VIRGINIA ELECTRIC AND POWER COMPANY
RICHMOND, VIRGINIA 23261

January 27, 2010

Serial No. 09-223
NLOS/GDM R1
Docket Nos. 50-280
50-281
License Nos. DPR-32
DPR-37

VIRGINIA ELECTRIC AND POWER COMPANY (DOMINION)
SURRY POWER STATION UNITS 1 AND 2
LICENSE AMENDMENT REQUEST
MEASUREMENT UNCERTAINTY RECAPTURE POWER UPRATE

TS FIGURE 2.1-1

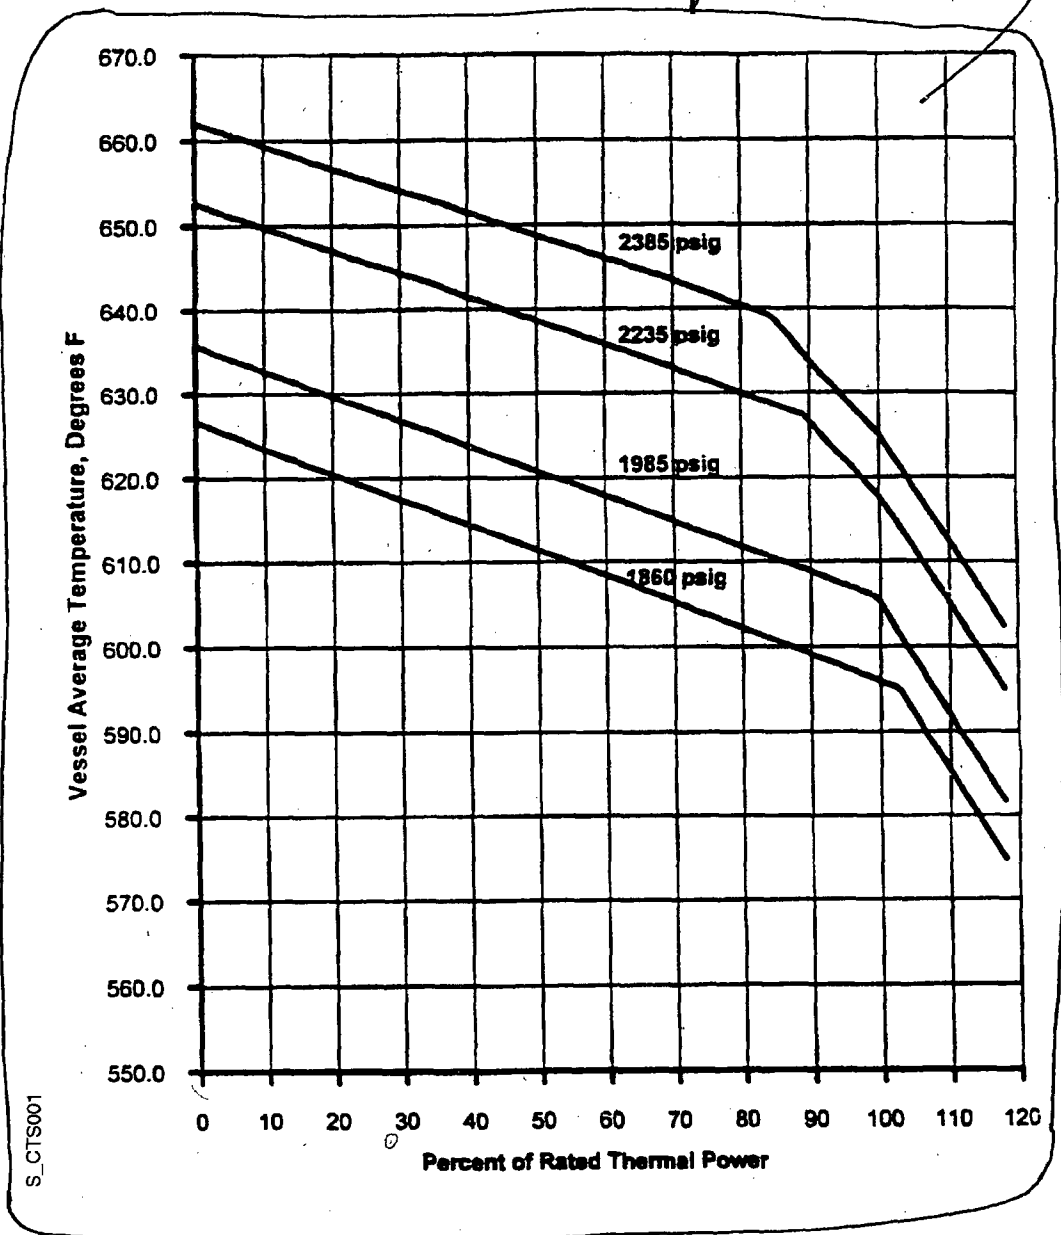
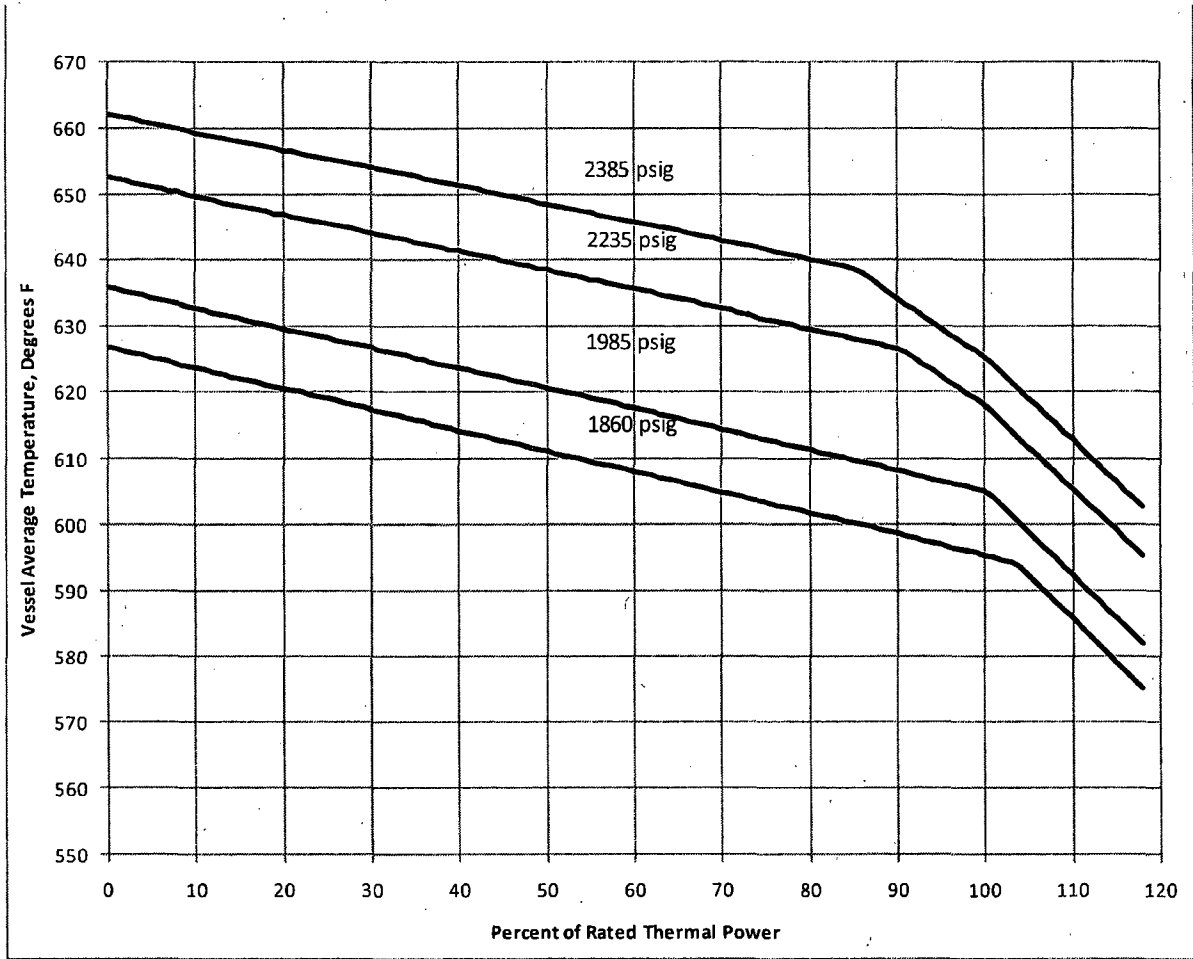
Changes are required to the Reactor Core Thermal and Hydraulic Safety Limits in TS Figure 2.1-1. Revised Reactor Core Safety Limits (RCSLs) have been developed to reflect MUR operating conditions. The RCSLs are defined as the most limiting of vessel exit boiling, hot channel exit quality, and the core Departure from Nucleate Boiling considerations. The RCSLs were evaluated using the approved Westinghouse methodology described in WCAP-8745-P-A, *Design Bases for the Thermal Overpower ΔT and Thermal Overtemperature ΔT Trip Functions*, September 1986.

INSERT TS FIGURE 2.1-1

Figure VIII-1
Reactor Core Thermal and Hydraulic Safety Limits
Three Loop Operation, 100% Flow

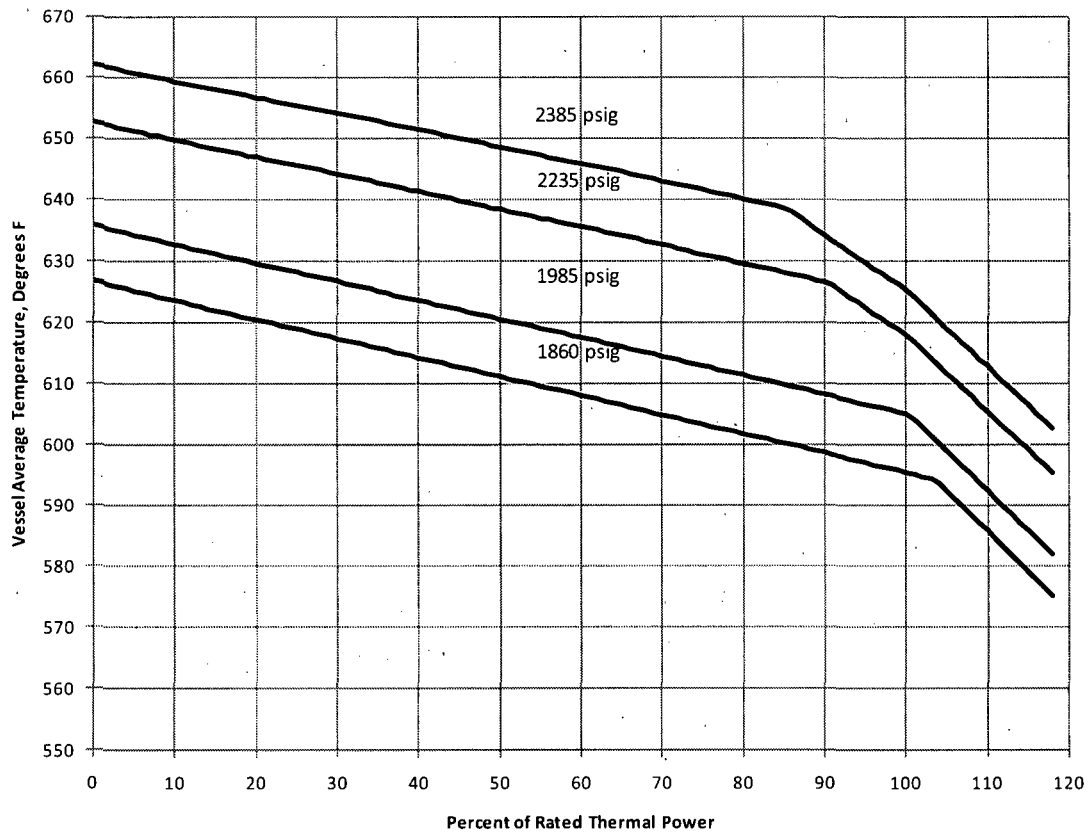
- TS 2.1 identifies the Reactor Core Safety Limits, which provide the combination of reactor thermal power level, coolant pressure and coolant temperature that ensure fuel limits are met. Revised core safety limit lines for Technical Specifications Figure 2.1-1 were developed to reflect MUR operating conditions at 2587 MWt. Figure VIII-1 documents the limit lines that were generated using the NRC-approved methodology in Reference VIII-1. Figure VIII-1 replaces current TS Figure 2.1-1. TS Figures 2.1-2 and 2.1-3

Figure VIII-2
Surry Rod Withdrawal at Power
Minimum DNBR vs. Insertion at 2589.3 MWt (101.7% of 2546 MWt)

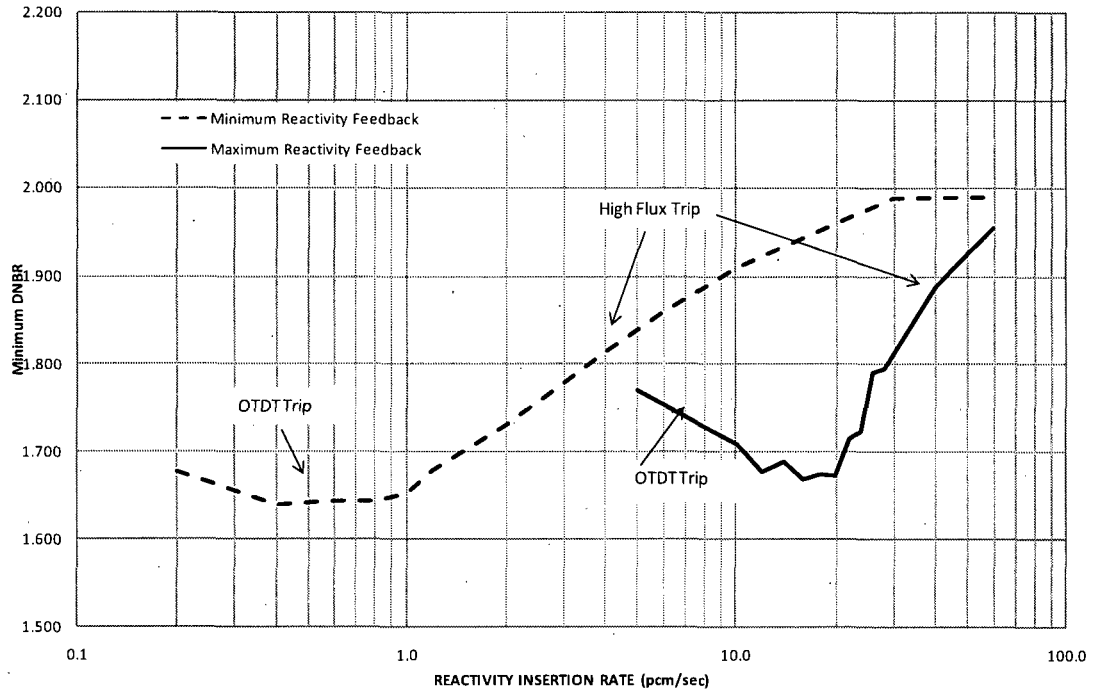
- The OTΔT K3 constant was input as 0.000770.
- For a given initial power level, the limiting DNBR occurs for the reactivity insertion rate that produces an OTΔT and high neutron flux trip at essentially the same time. Figure VIII-2 shows the results of the MUR analysis at 101.7% power. The intersection of the different protection functions compares closely to UFSAR Figure 14.2-5. For this reanalysis, a minimum DNBR of 1.64 occurred for an initial condition of 101.7% of 2546 MWt, minimum reactivity feedback, and a reactivity insertion rate of 0.4 pcm/second. The combined effect of the OTΔT K3 increase and the power increase results in a slightly lower reactivity insertion rate becoming the limiting case (UFSAR limiting case is at 0.8 pcm/second). The minimum DNBR of 1.64 is a small decrease compared to the current limiting result of 1.68 at 2546 MWt. The new analysis minimum DNBR is above the DNBR design limit of 1.46. Further, a penalty against retained DNBR margin for the MUR power uprate is not required for the RWAP event in UFSAR Section 14.2.2.
